Access Compliance Report

Public Rights-of-Way

(Curb Ramps)

Intersection ID: 53963	Main Street: MAGNOLIA LILY AV	Cross Street: LILAC TREE AV	Location: SW
ADA ID: 030BCB2E238F	Ramp Type: Perp	Initial Pass/Fail: Fail	Overall Compliance: No
Severity Score: 10			
Codes/Mitigation Info/Possible Solution		Field Measurements/Component Compliance

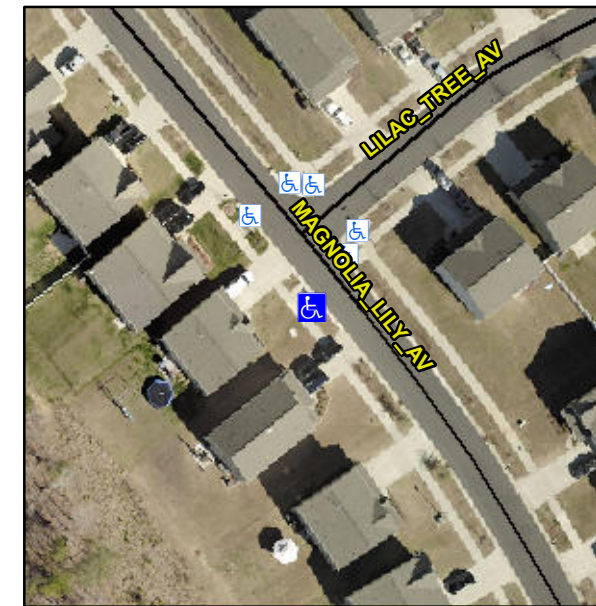
Not Found, R304.5.1, R304.5.3

Compliance	Description	Data	Compliance	Description	Data
N/A	Ramp Length (in)	94.0	Yes	Ramp Slope (%)	7.0
No	Ramp Width (in)	47.5	No	Ramp XSlope (%)	2.4
N/A	Flare Type LT	N/A	N/A	Flare Type RT	N/A
N/A	Flare Slope LT (%)	N/A	N/A	Flare Slope RT (%)	N/A
N/A	Flare Traversable LT?	N/A	N/A	Flare Traversable RT?	N/A
N/A	Landing Length (in)	N/A	N/A	DWS Provided?	N/A
N/A	Landing Width (in)	N/A	N/A	DWS Contrast?	N/A
N/A	Landing Slope (%)	N/A	N/A	DWS Length (in)	N/A
N/A	Landing X Slope (%)	N/A	N/A	DWS Full Width?	N/A
N/A	Landing Curb? (Y/N)	N/A	N/A	DWS Offset (in)	N/A
N/A	Shared Landing?	N/A			
N/A	Gutter Ponding?	N/A	N/A	Gutter Slope (%)	N/A
N/A	Gutter Lip Ht (in)	1.0	N/A	Gutter X Slope (%)	N/A
N/A	Painted X Walk1?	No	N/A	Painted X Walk2?	N/A
	X Walk 1 Direction	To E		X Walk 2 Direction	N/A
N/A	X Walk 1 Width (in)	N/A	N/A	X Walk 2 Width (in)	N/A
	X Walk 1 Slope (%)	3.5		X Walk 2 Slope (%)	N/A
	X Walk 1 X Slope (%)	1.9		X Walk 2 X Slope (%)	N/A

Possible Solutions:

Remove & Replace Entire Ramp.
